Town of Parker Community Development Department
Development Review Division
Attention: **Amber Wood Hicken**

Application Type: **Site Plan**
Status: **First Referral**
Application Name: Parker Pointe F1 AMD 1 L2A - McDonald's Site Plan
Case/AP#: **SP23-070**
Referral Received: October 11, 2022
Comments Due: November 8, 2022

Review date: **October 23, 2022**
Plan reviewer: **Randall L. Capra**, rcapra@parkeronline.org
Phone: 303.805.3163

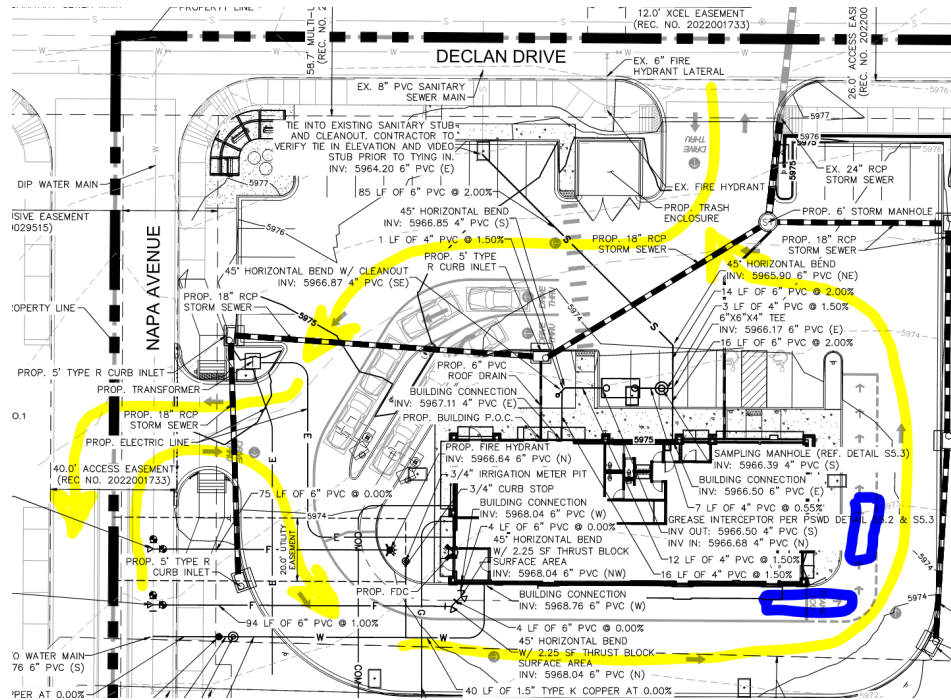
- 3. The applicant shall provide an auto turn analysis indicating that apparatus can navigate all portions of this site; NO PARKING – FIRE LANE signage is required for any portion of the access where the 20-foot clear width requirement cannot be met. In this case, the applicant has provided an auto turn analysis for a portion of the site; the applicant shall update the analysis to include the right in/right out entry on the south portion of the site; see below and address when resubmitting:

Note – the area identified with the two blue rectangles is of particular concern. People tend to not stay within the lines and the 20-foot drive aisle on the south end creates a potential for delays in response specific to staged or waiting vehicles in this area. Ensure that this issue is addressed adequately or provide signage that states **NO PARKING OR STANDING – FIRE LANE** in this area (area shown on west side of building... south end as well as the south side of the building). *Satisfied; applicant has noted or acknowledged or addressed with the second submittal. The information will be shared with SMFRA so that there preplans can address this issue accordingly.*

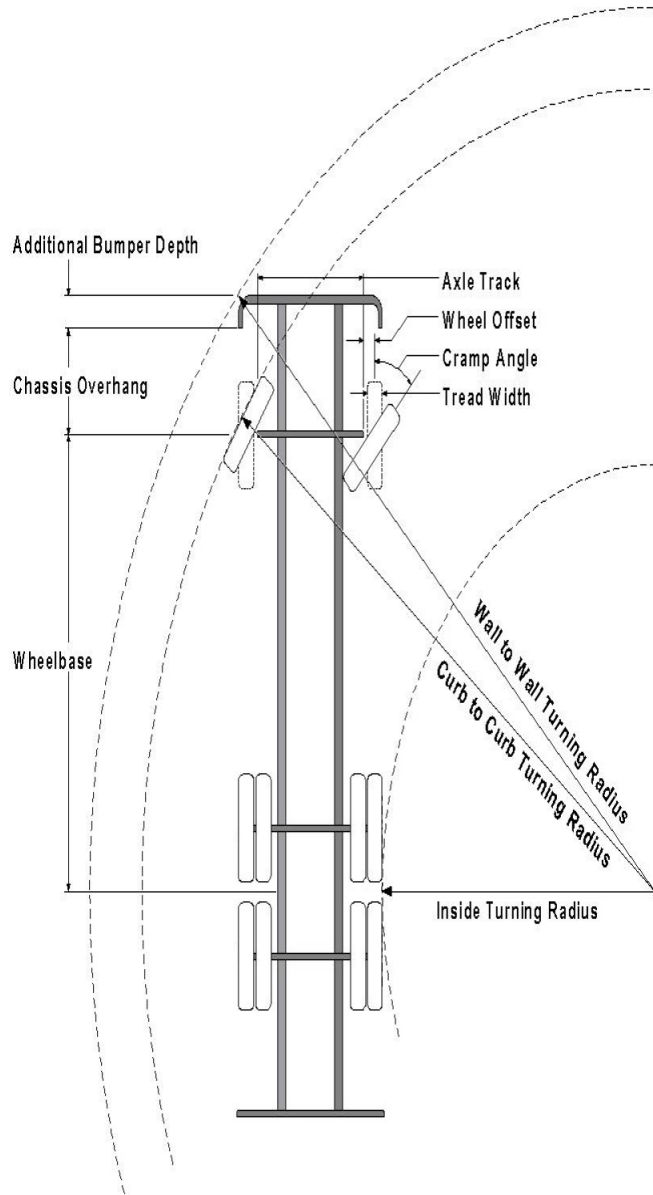
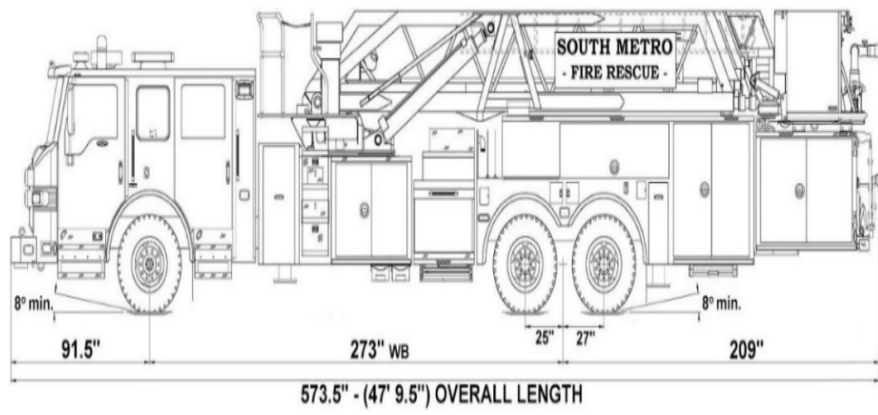
- 4. The applicant shall provide NO PARKING – FIRE LANE signage for any portion of the access where the 24-foot clear width requirement cannot be met; areas that are required to have this signage are located on both the north and sides of the building. See below for areas highlighted in yellow: *Satisfied; applicant has noted or acknowledged or addressed with the second submittal.*
